**Introduction:** The following report documents a process change incorporated into the SP205-01 wafer production process with the objectives of improving product consistency and yield. This report also describes the testing and analysis performed to quantify the potential impact of the process change. This work was completed with the assistance and technical oversight of the Defense Microelectronics Activity (DMEA).

**Updated Process:** The following changes have been implemented to the wafer back-side processing steps prior to metal deposition:

Figure 1: Typical Back-Side Optical Image

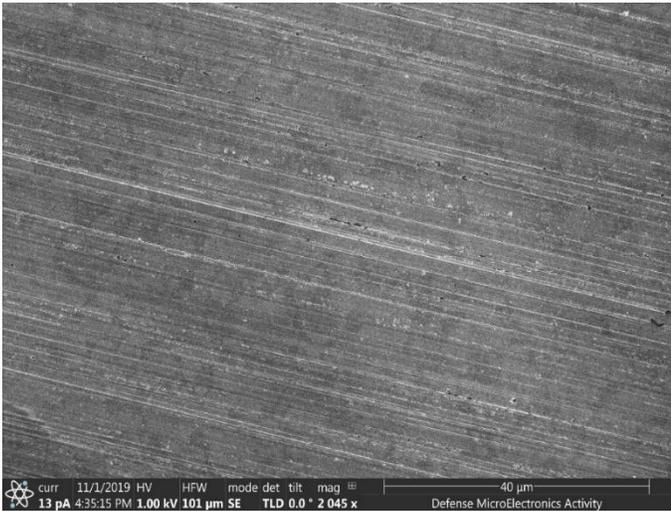
Figure 1. illustrates the typical results of the optical inspection of the samples. Striation due to back-grinding and surface scratching was observed on all samples.

Figure 2: SEM Image of Substrate with Metal

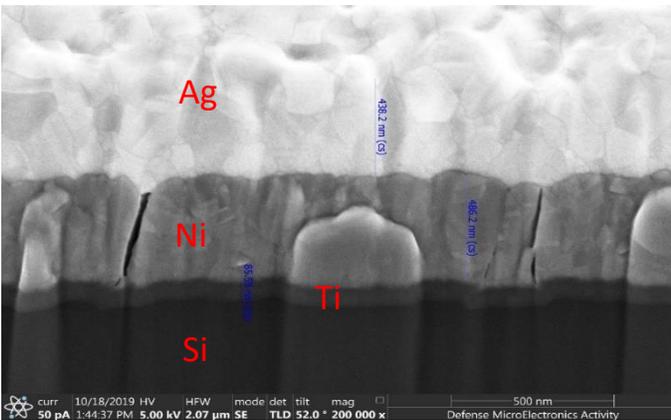
The backside metallization on two samples was removed with an H<sub>2</sub>SO<sub>4</sub> etch formulated to leave the Silicon intact (Figure 2).

Following the etch, these samples were inspected utilizing DMEA’s FEI dual beam Focused Ion beam (FIB) tool. The objective of this inspection was to detect any signs of micro-cracking originating from the striations left on the samples after back grinding. No signs of brittle fracture or lattice damage were observed on these samples.

Figure 4: Wide-View Cross-Section (DMEA)

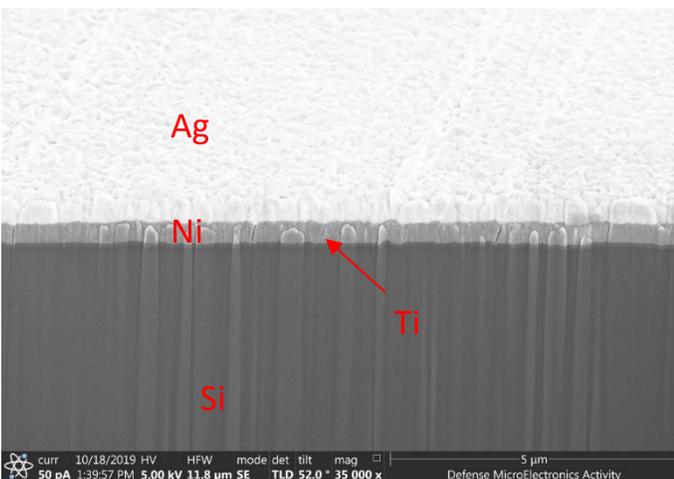
Figure 4 illustrates a much wider cross section of the substrate area. This was done with the dual purpose of exposing brittle fracture radiating below the surface from striation valleys resultant from the back-grinding process, and to ensure that the sputtered Ti/Ni/Ag plating was within specification. The plating was found to be within specification, and no radial fracture sites were observed.

Figure 2: Typical EM Analysis Result: Comparative analysis of the 240 MHz Bandwidth. Known Good Sample (Yellow) and modified (Back Grind) Sample (Blue)

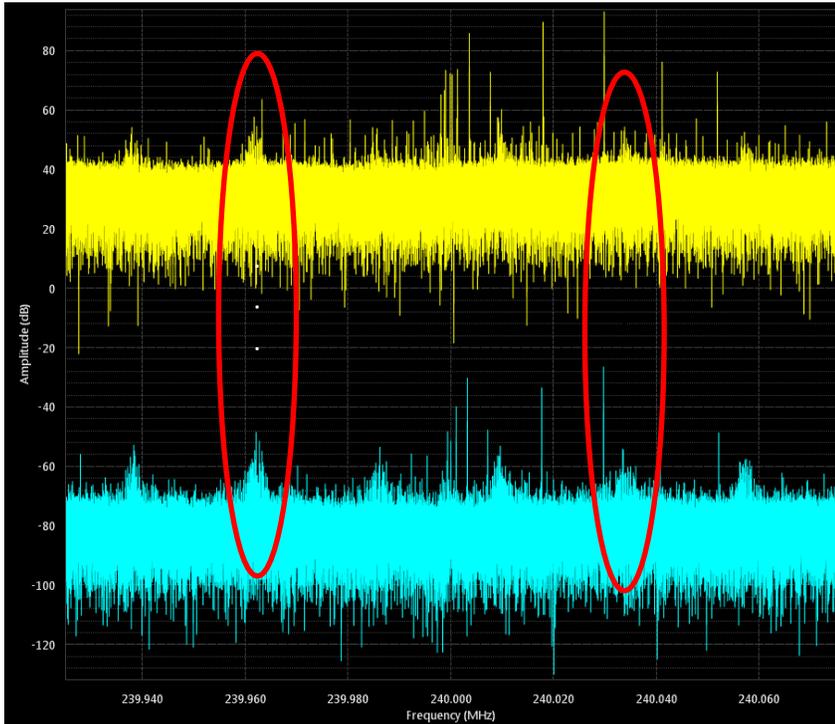
Figure 5 illustrates a typical result for the EM analysis of the samples provided to DMEA by Silicon Power. The blue spectral data represents the emission spectra of a device exposed to back grinding. The yellow spectrum is a device from an earlier date code device that was not subject to back grinding.

Degradative effects typically manifest as large frequency shifts in the fundamental and harmonic content of a degraded component spectral data. Figure 5 clearly shows that the fundamental and harmonic peaks of both signals illustrated in Figure 5 are nearly coincident in frequency. There is a slight increase in the energy density associated with the nonlinear mixing product of the modified sample, indicating that change has occurred in the current flow through the device, when compared to the same sub-bands of the unmodified device (in the sub bands encompassed by the red highlight shown on Figure 5.) However, the absence of major frequency shifts in the fundamental and

harmonic content between the spectral plots illustrated in Figure 5 indicate that the change due to stress induced by the back-grinding process was minimal.

Figure 6: EDS Results Illustrating No Nitrogen Peaks (DMEA)

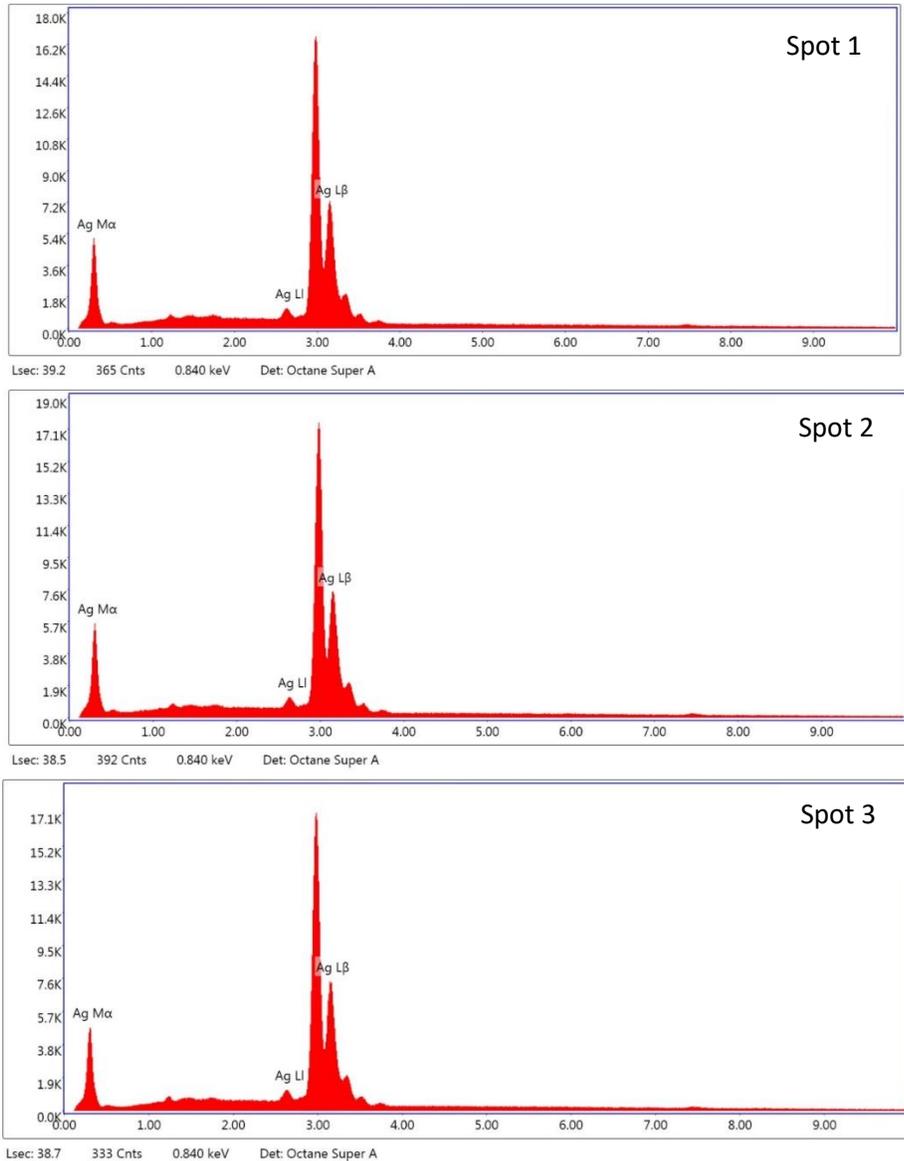
**Energy Dispersive X-ray Spectroscopy (EDS) Results:** DMEA performed EDS analysis at random locations of the back side of three metallized samples provided by Silicon Power with the objective of validating that the back-grinding process had in fact removed residual nitride films used as a mask during wafer fabrication. The spectral data did not reveal the presence of a nitride film or any contaminant on the analyzed samples.
